Aviation DOA Nr.: EASA.21J.025	<b>Service Information</b>	Dokument Nr.: <b>SI-AT01-018</b>
	<b>Laufende Modifikationen/ continuous modifications</b>	Ausgabe/Issue: A.18 Seite/Page: <b>1 of 2</b>

## Service Information SI-AT01-018

#### A-2 Subject:

Continuous modifications and changes to parts and appliances are cumulatively detailed and published within this SI.

## Calibration of float-type fuel gauges

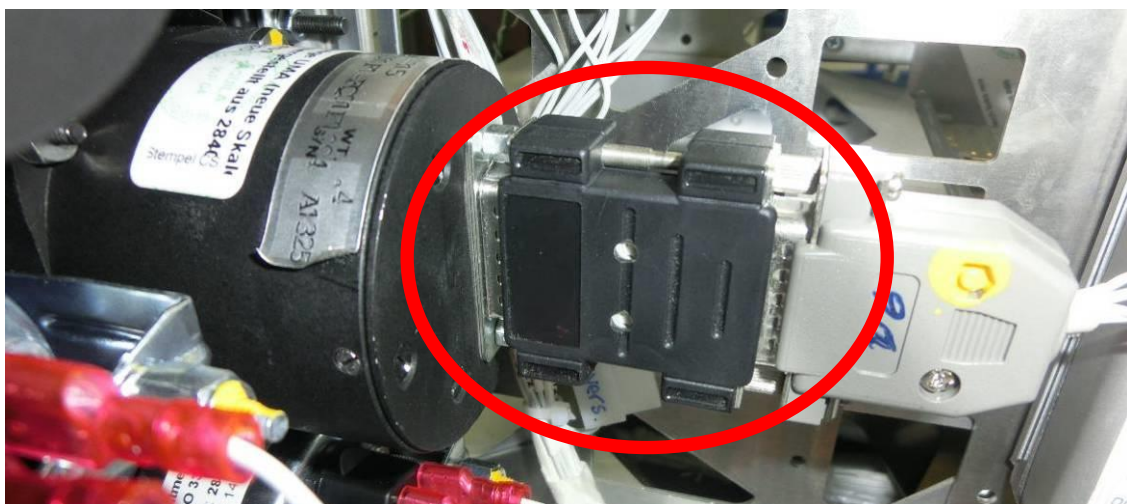
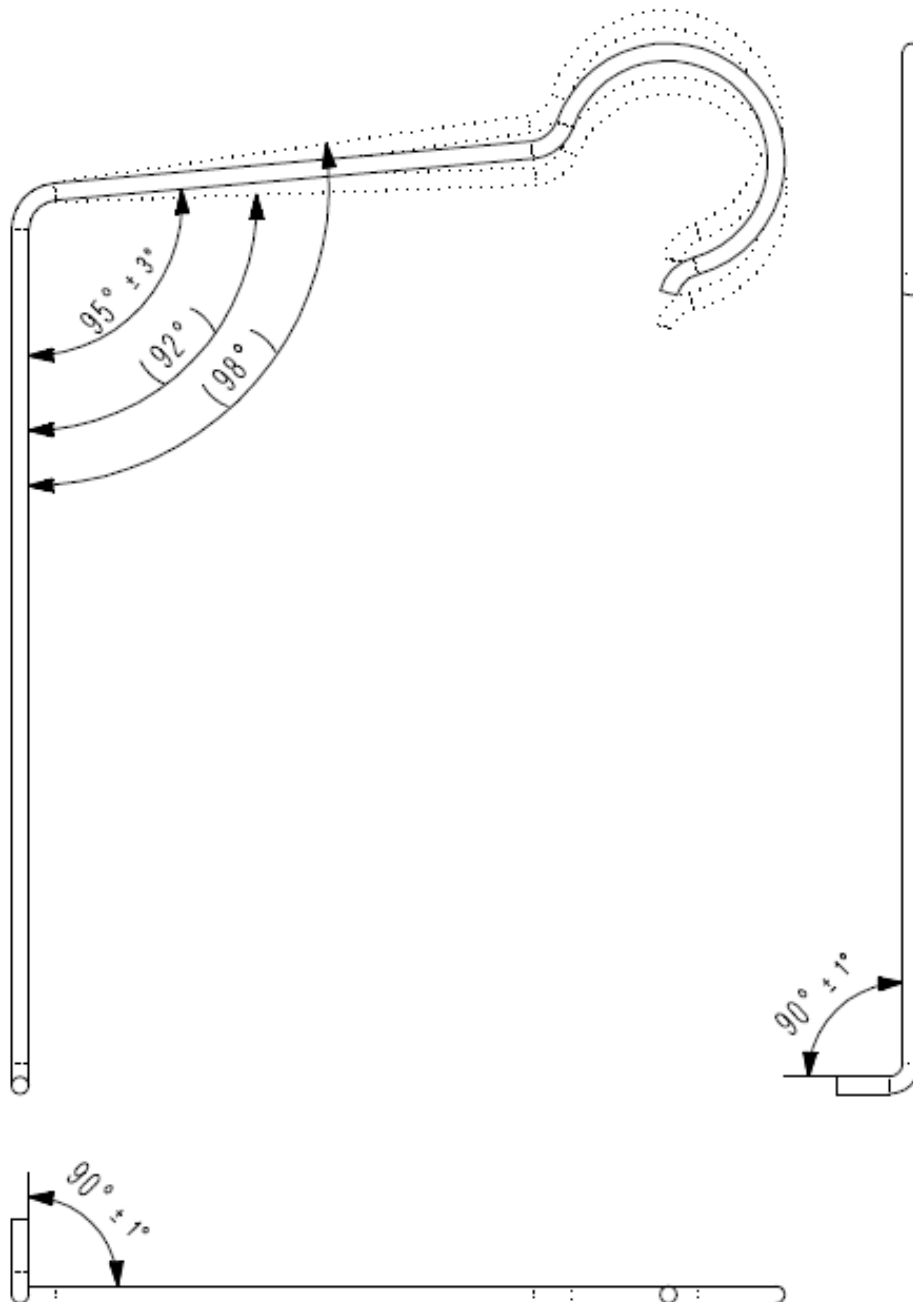
1. Remove both fuel level sensors according to maintenance manual.
2. Replace old float levers (AT01-8030-178) by new levers (AT01-8030-186).  
**Caution:** Install floats in the same direction they were installed before (facing towards the wing's leading edge). Check levers for free movement.
3. Reinstall both fuel level sensors according to maintenance manual.

4. Remove glare shield.
5. Remove connector at the back of the fuel gauge.
6. Check type of fuel gauge (new/old pin-out, AT01-2840-206 or AT01-2840-220, refer to annex 1 of this SI for further information)
7. Install correct calibration module (AT01-8040-001 or AT01-8040-002) between fuel gauge and harness connector as shown below:

- 1x calibration module AT01-**8040-001** (for gauge with new pin-out AT01-2840-220)  
     OR:            AT01-**8040-002** (for gauge with old pin-out AT01-2840-206)
- 2x float lever        AT01-**8030-186**

## PU-hose coolant overflow

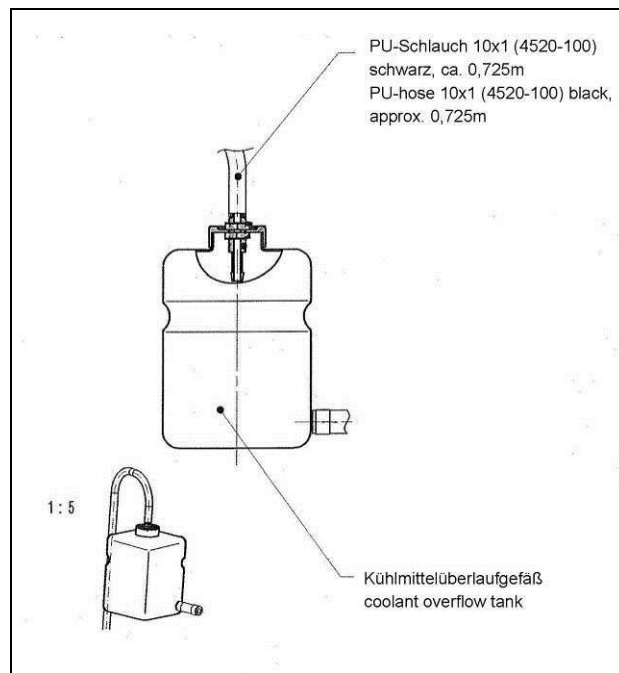
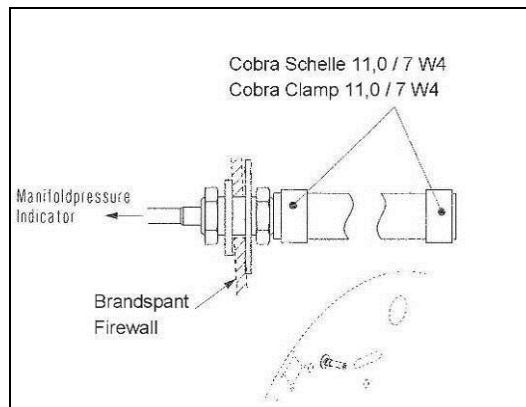
The transparent PE-hose at the coolant overflow tank can be blocked due to tie wraps at high temperatures. Thereby coolant can be released from the over pressure bore at the coolant overflow tank and contaminate the engine compartment.

In some cases the manifold pressure connecting hose from the firewall to the carburetors connecting bridge is attached with tie wraps. To ensure an accurate measurement Cobra clamps should be used.

**new:** 2x Cobra clamp 11,0 / 7 W4 (AQUILA P/N **4520\_COBRA\_11,0/7W4**)

The following excerpt from the schematic depicts the pinout of the connectors:

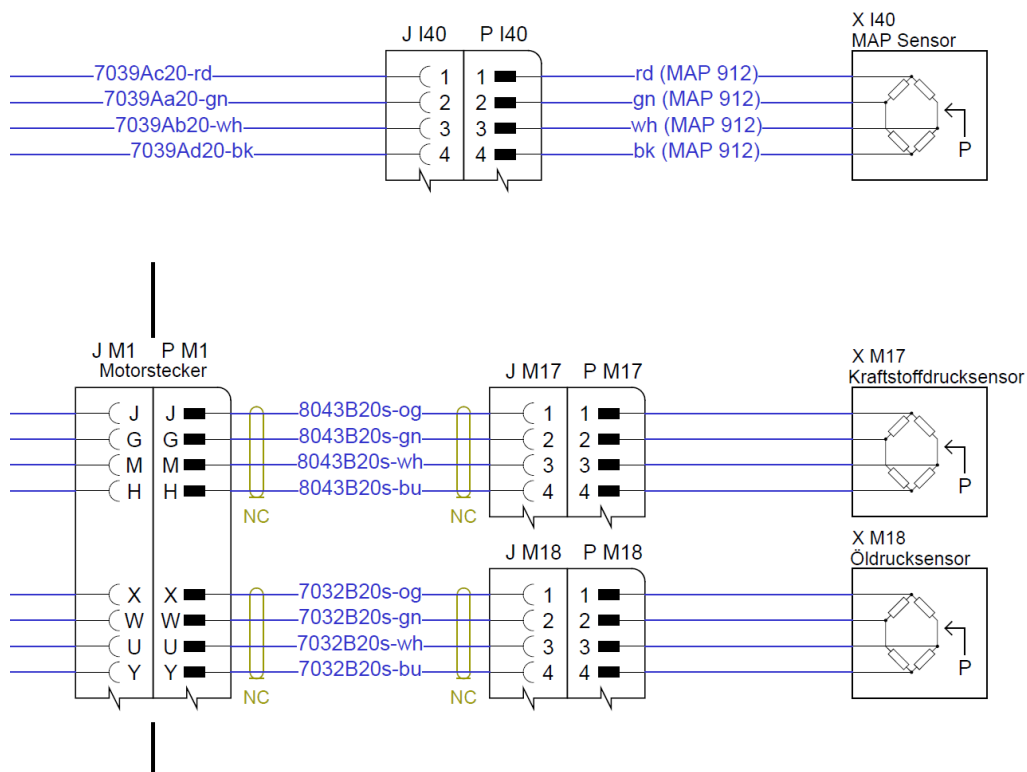
Note that these connectors are not authorized for use in thermocouple wiring!

**1x bracket, separated radiators:** AQUILA TNr. **7050-149**

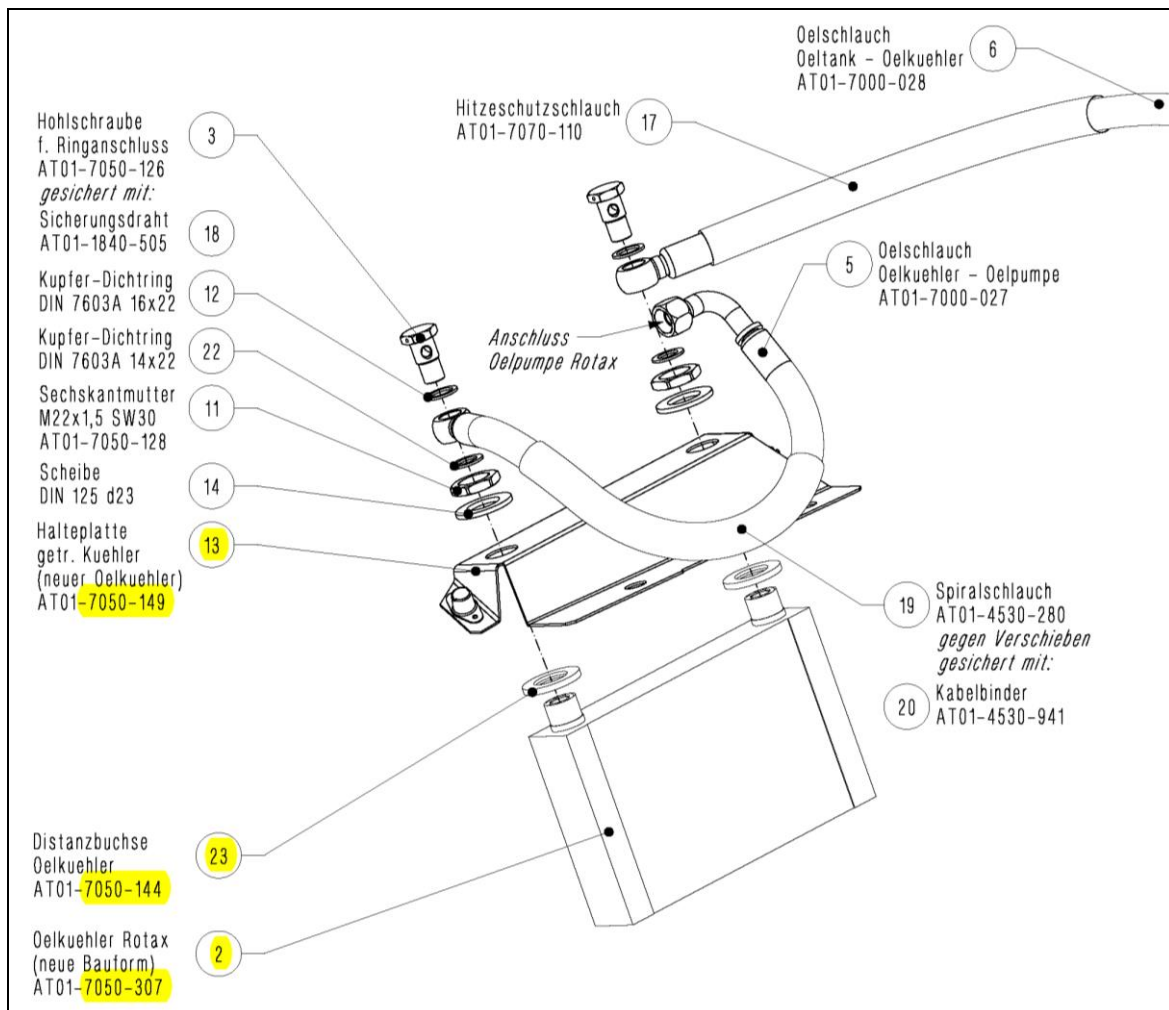
With SI-912-024 ROTAX has published the introduction of a new oil radiator (Rotax P/N 886004).  
 The former design (Rotax P/N 886024) is no longer available.  
 For embodiment of the oil radiator with new design a modified bracket and two Teflon spacer disks are required.

**pitot heated, Lemo socket, old pin assignment:**  
 AQUILA P/N 7710-104-R04 (S/Ns 051, 053, 054, 055 only)

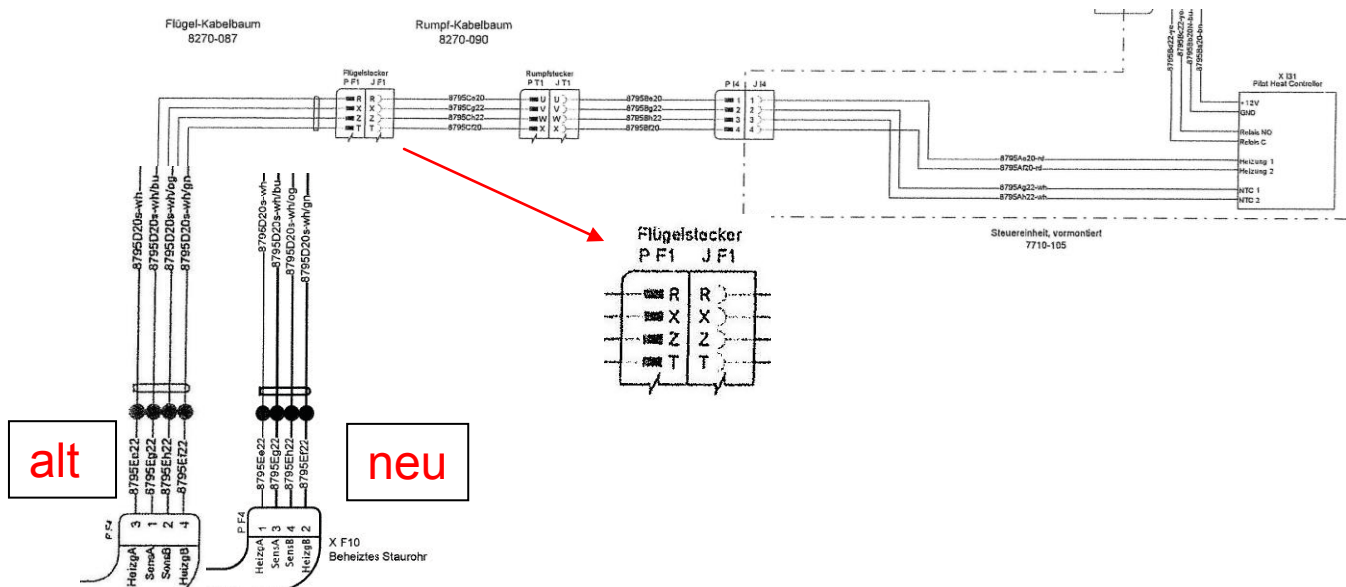
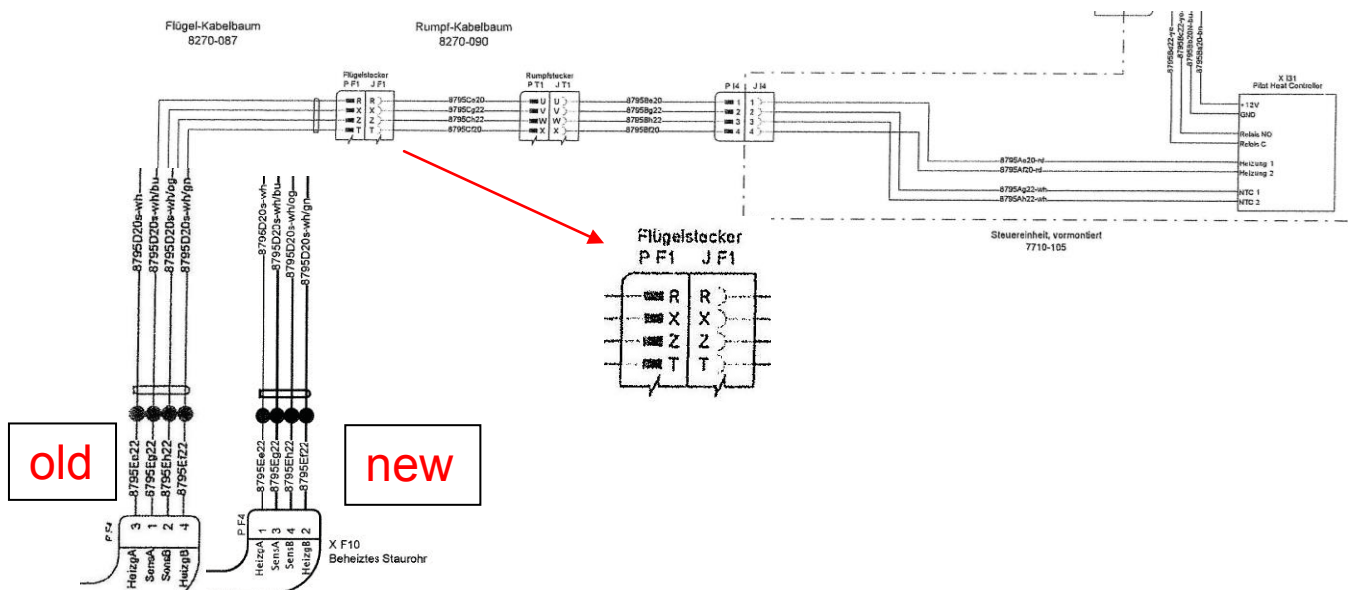
1. remove old pitot tube
2. enlarge pitot mounting hole diameter within the wing by cutter upon  $\sim\varnothing 30\text{mm}$  (check fit with new pitot)
3. remove 4-pole plug from wing harness
4. a) install Lemo plug onto wing harness for AQUILA P/N **7710-104-R05** or higher, pin config. at pitot: **socket pins 1 and 2 to heating; plug pins 3 and 4 to sensor NTC**; Mantle the four wires with a heat shrink tube in the area of the strain-relief of the plug.  
 b) deviating for AQUILA P/N **7710-104-R04 (S/Ns 051, 053, 054, 055 only)** pin config. at pitot: **socket pins 1 and 2 to sensor NTC; plug pins 3 and 4 to heating**
5. connect plug and socket and install pitot
6. conduct a test run with check for heating up of the pitot and disappearance of the amber pitot warning in the cockpit

fig.: extract from draft IPC

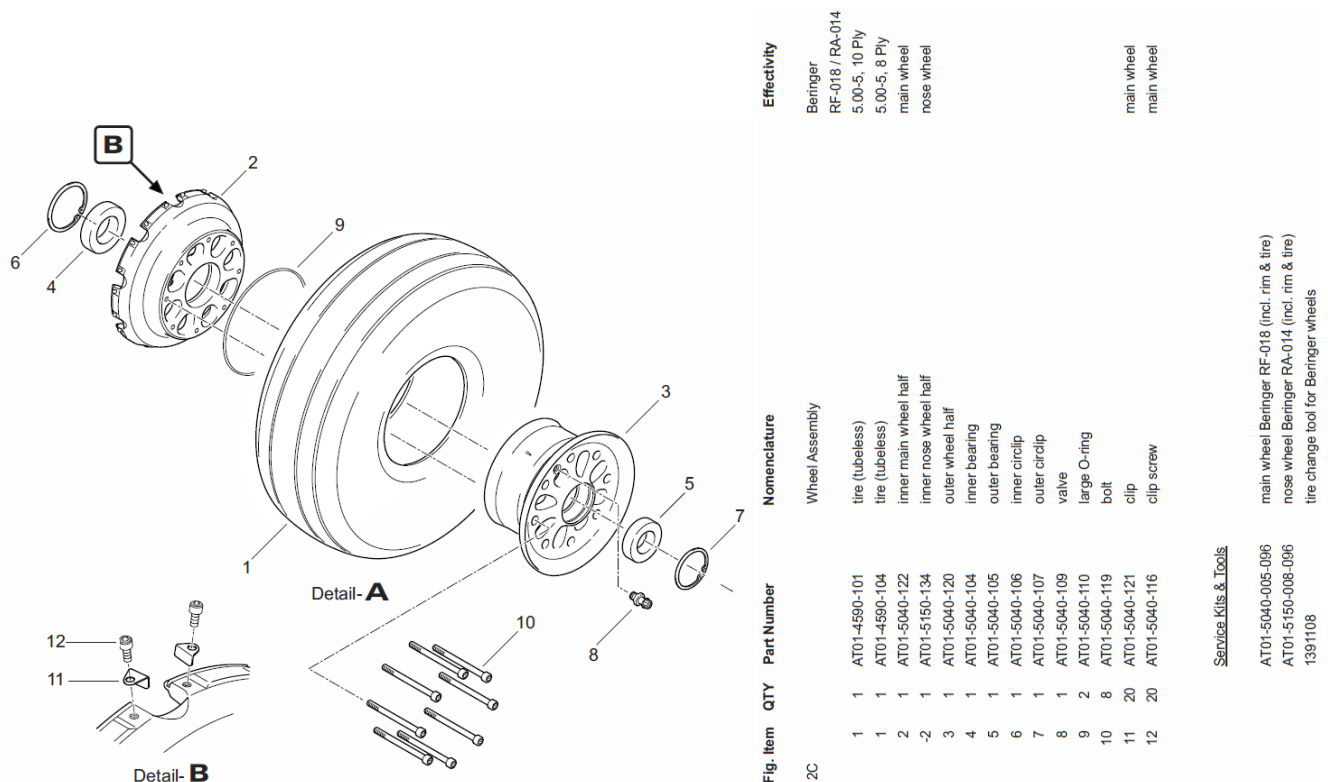
No change to tire pressure, TBOs or tooling.

Implementation of SI-AT01-018 annex 22 has to be approved and released to service by certifying staff.

Fig.: extract from "The Ray Allen Company" RP4 LED Position Indicator Datasheet

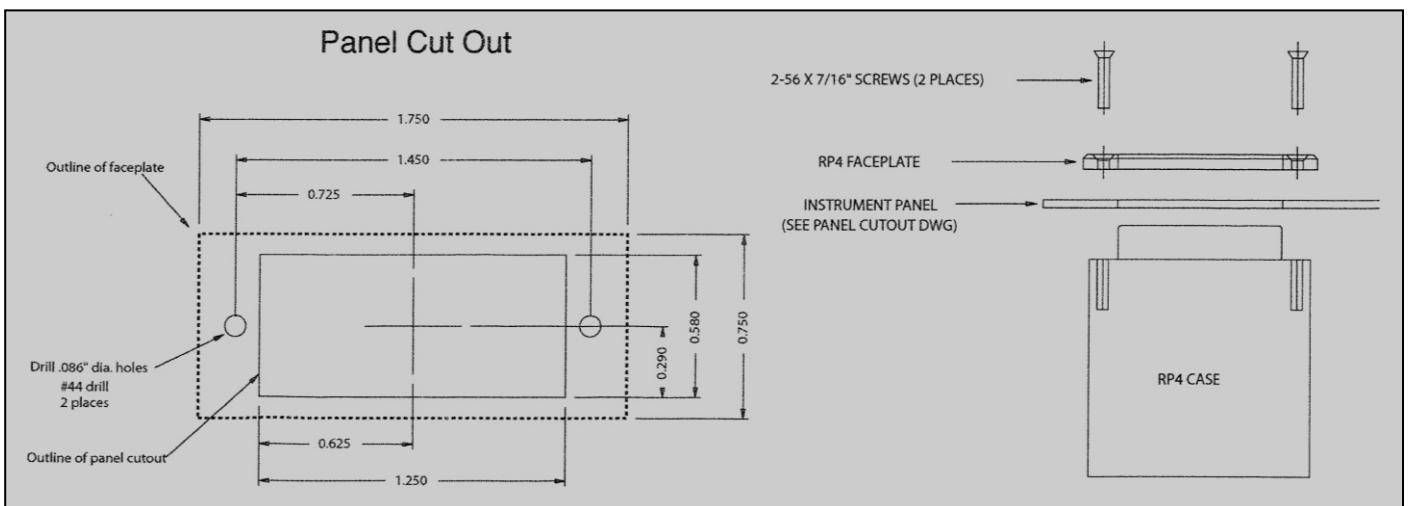
1. Disconnect electrical connector and remove defective trim position indicator
2. Enlarge Panel Cut Out acc.sketch below (ca. +1,5mm in height and width)  
**Suction the resulting chipping appropriately!**
3. Install new trim position indicator (LEDs to LH) and restore electrical connection
4. Place indicator marking (DN Trim oriented up / forward)
5. Perform functional test
- (6.) If indicator is unsteady, or interfered during COM use, exchange Pin 1 (green) and Pin 2 (blue), afterwards readjust trim range if needed

**AT01-8220-080**  
*Flaps switch new*

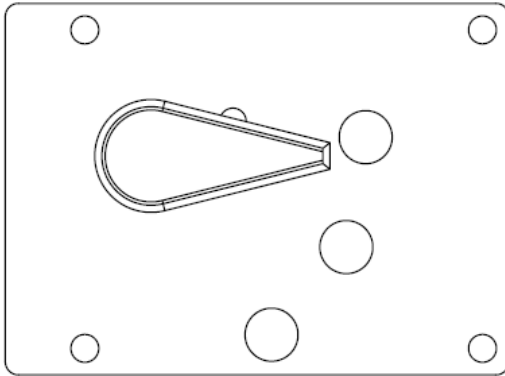
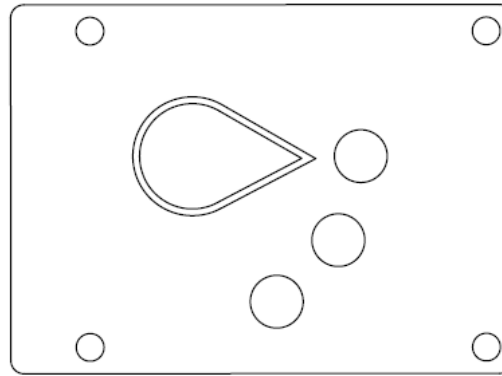
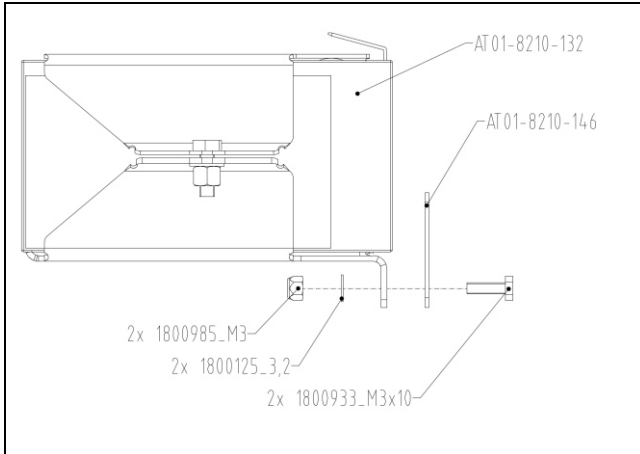
Der bisherige Landeklappenschalter AT01-8220-067 wird nicht mehr hergestellt und kann bei Bedarf durch den neuen Schalter ersetzt werden.

1. disconnect electrical connector at flaps switch and remove switch including cover panel from instrument panel
2. install new pre-assembled flaps switch
3. Model AT01 only: apply placards (CRUISE, T/O, Landing)
4. using adapter cable AT01-8220-081 connect existing electrical connector in the instrument panel) with new flaps switch connector
5. Using cable ties, tie new adapter cable to existing harness. If necessary, substitute old cable ties by new ones to prevent for chafing!
6. perform functional test

**FORMER** Integration of emergency excitation battery

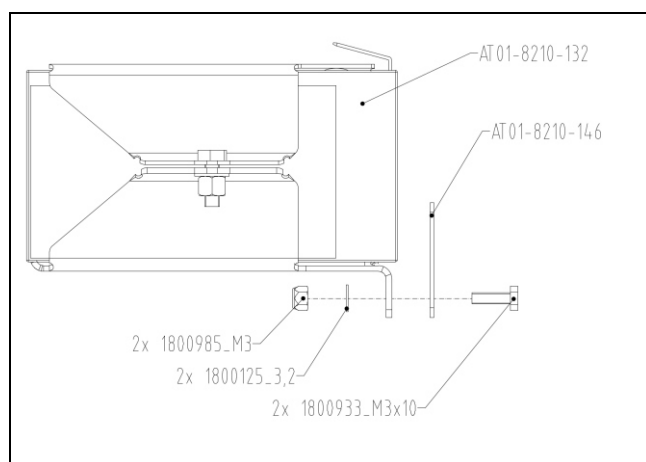
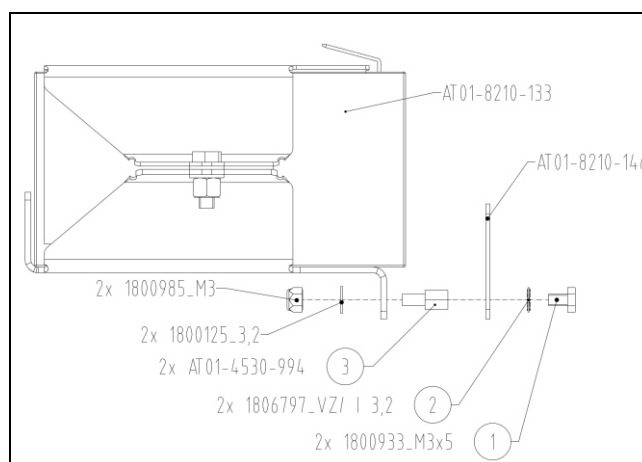
The emergency excitation battery AT01-8210-132 is no longer in production. The retrofit to the successor model AT01-8210-133 is approved herewith in case of the need for replacement. Other/additional fastening elements are needed for attachment of the new battery, because it has slightly different dimensions.

1. Disconnect wire from emergency excitation battery AT01-8210-132
2. Unfasten attachment plate AT01-8210-146, do not reuse screws AT01-1800933\_M3x10
3. Extract AT01-8210-132 out of attachment, insert AT01-8210-133
4. Fasten attachment plate AT01-8210-146 with spacer bolts, tooth lock washers and screws (s. figure above)
5. Connect wire to AT01-8210-133
